Approved Septic System Plan
Howard County Health Department

BURLEIGH
MANOR
LOT 686

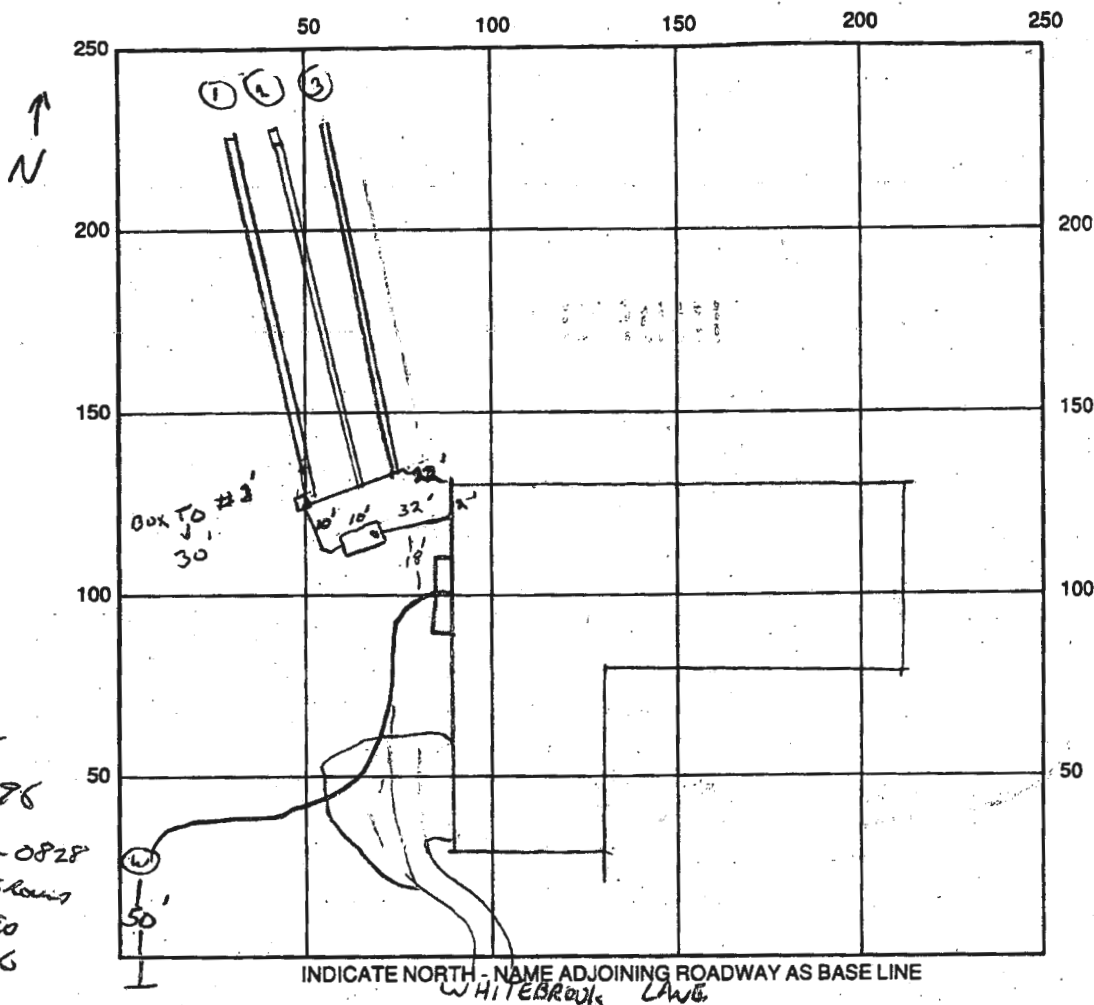
WPI
11-8-96
OK
HO-88-0828
NEEDS GRASS
ATTACHED
TO CALLING

REMARKS: 11/6/96 OK TO COVER SYSTEM, NEEDS HOUSE CONNECTION

FOR FINAL 11-8-96 HOUSE CONNECTION OK.

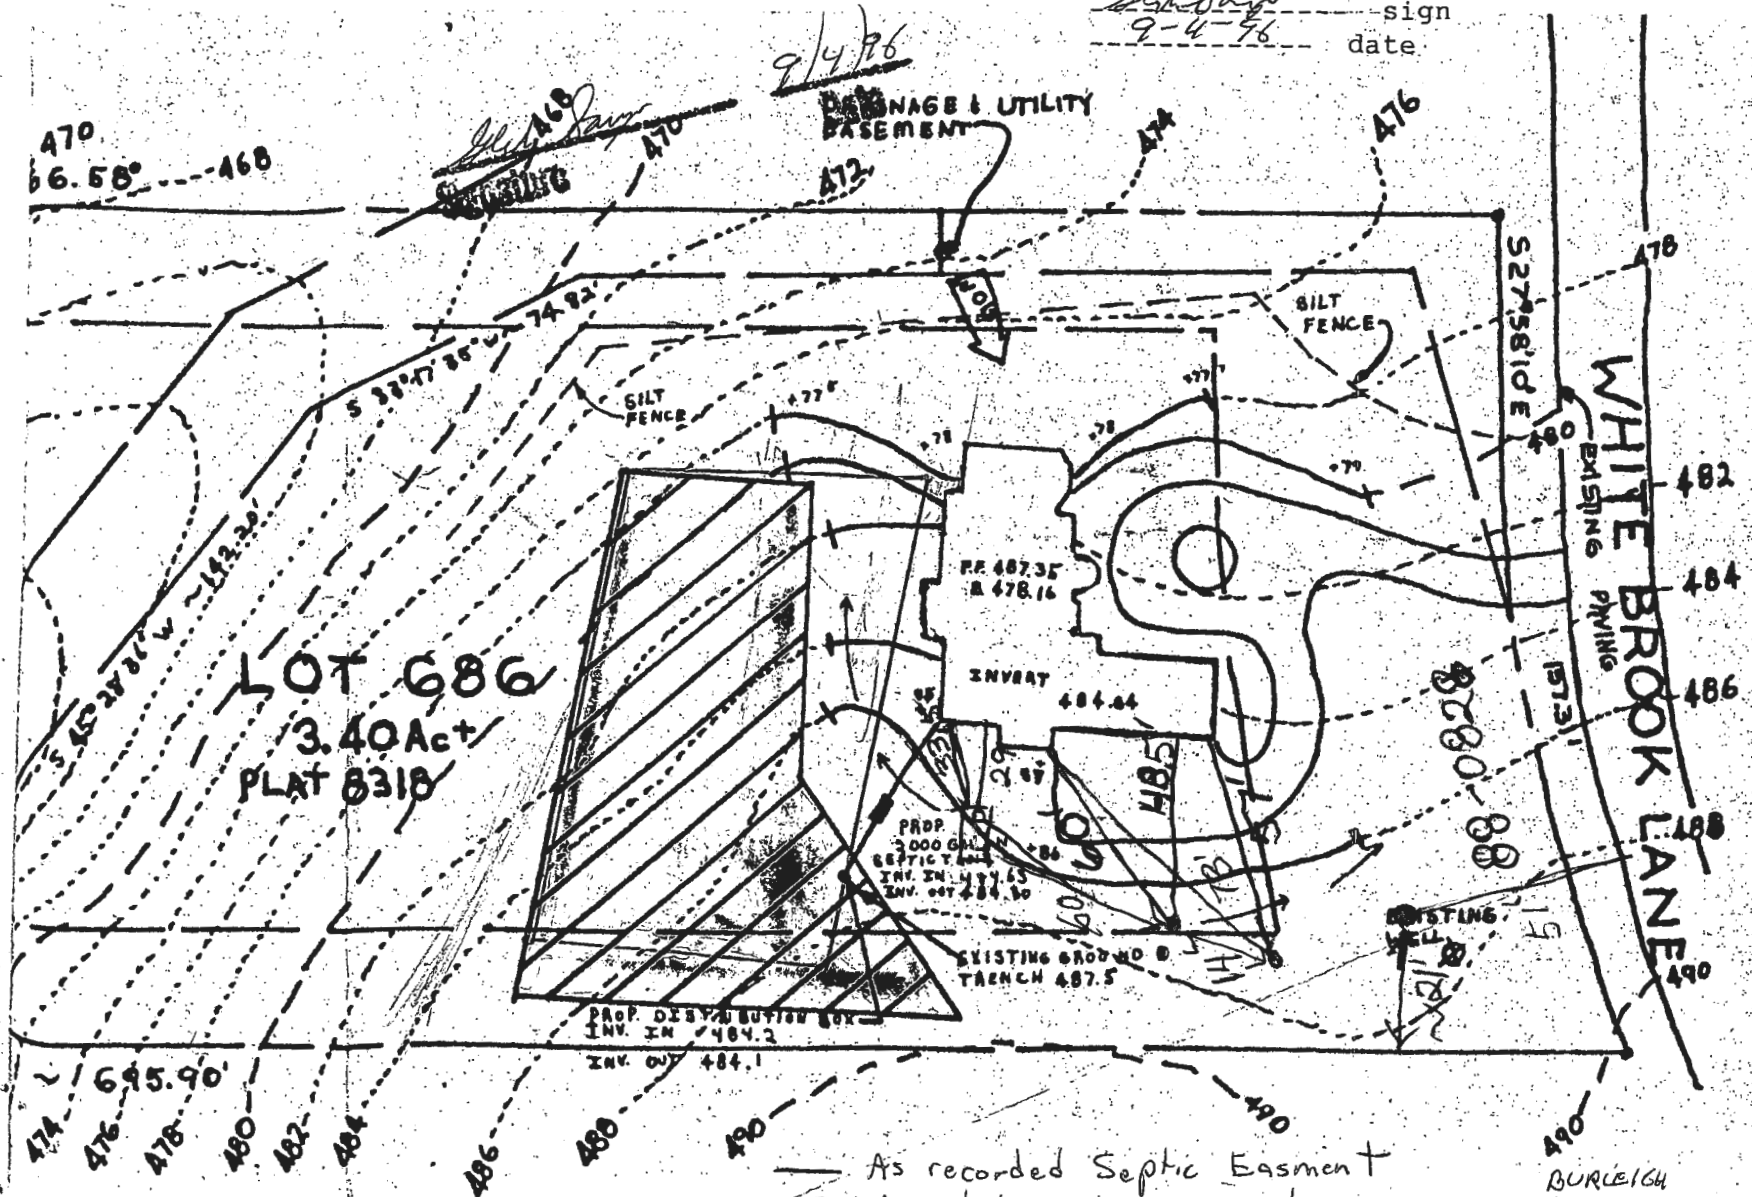
I wish to resive my ~~current~~ ^{Septic System Plan} septic easement
as shown in red ~~to the proposed easement~~
as shown in ~~black~~ ^{red}.

pool to be adjusted in field to meet minimum requirement from septic field

1-2-97
Pool location to be adjusted in field (see note) OK to proceed
ALM

By copy of this approved
plan the Health Dept
accepts the proposed
modifications to the septic
easement.
